# CHANGE ORDER

Former Columbus Wood Treating  
58 Lafayette St  
Columbus, Indiana

CHANGE ORDER NUMBER: #3

**RWP ADDENDUM 2  
CLOSURE AND POST-CLOSURE  
FORMER COLUMBUS WOOD TREATING  
53 LAFAYETTE AVENUE  
Columbus, Indiana 47201  
Bruce Carter Associates, LLC  
February 18, 2014**

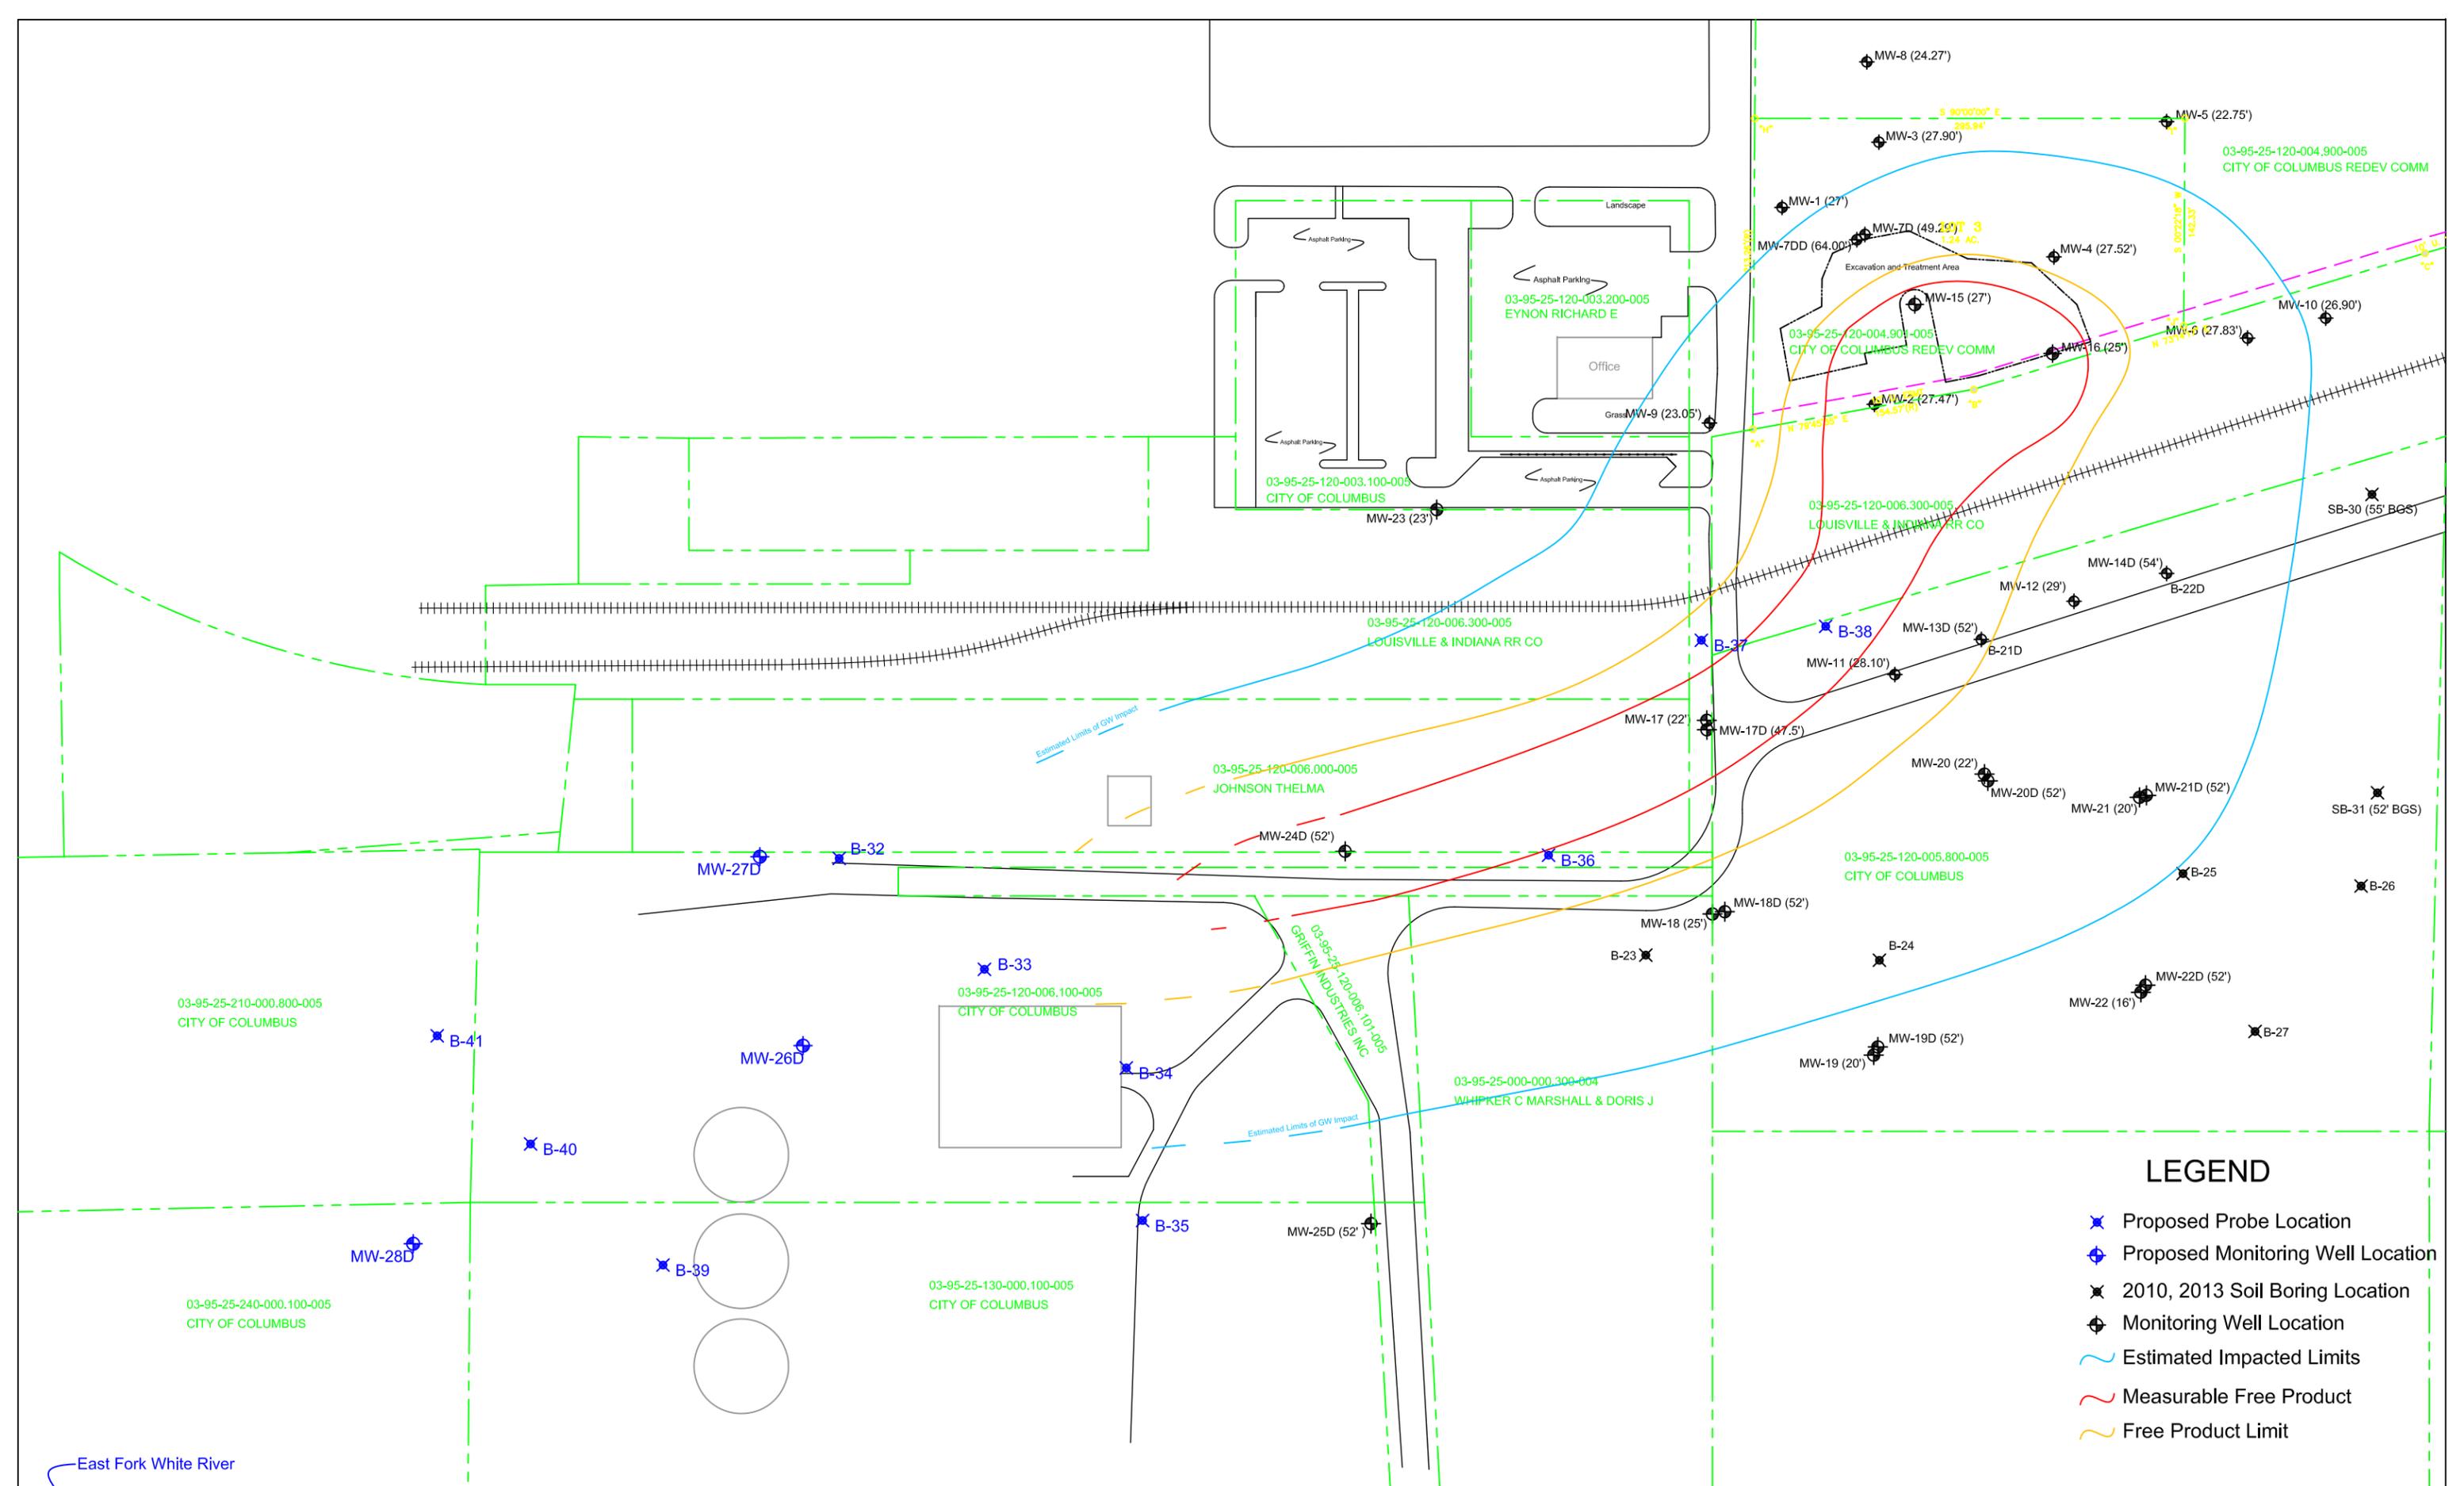
*Phase I* – Four (4) temporary direct push groundwater probes (B-32, B-33, B-34 and B-35) will be located as shown on the attached Figure A. Subsequent to the

probe installation, two (2) permanent monitoring wells (MW-26D and MW-27D) will be installed as near as practicable to the presumed center axis and on the northern edge of the plume, respectively. Specifically:

Free Product Delineation. Free product was recently identified in MW-24D and the downgradient extent of free product is not known. The downgradient limit will be determined during the plume delineation tasks described above. Once the limit is known, BCA will consult with IBP to determine the placement of three Free Product

Piezometer Probes (B-39, B-40, and B-41) that will be installed to the base of the aquifer. Although shown at the locations previously proposed on the attached Figure A, those locations will be adjusted after consultation with IBP. Soil will be sampled continuously during probe advancement near the bottom of the aquifer, and the presence and thickness of any visibly-impacted zone(s) will be noted on the boring logs. Permanent piezometers (1-inch ID PVC with 10-foot PVC screens) will be installed at the bottom of the probe and will be sealed to the surface and a steel protective cover will be installed in concrete. An interface probe will be used to measure for the presence and thickness of any free product (if any). Consistent with prior discussions, no groundwater or soil samples will be analyzed from probes/piezometers containing free product.
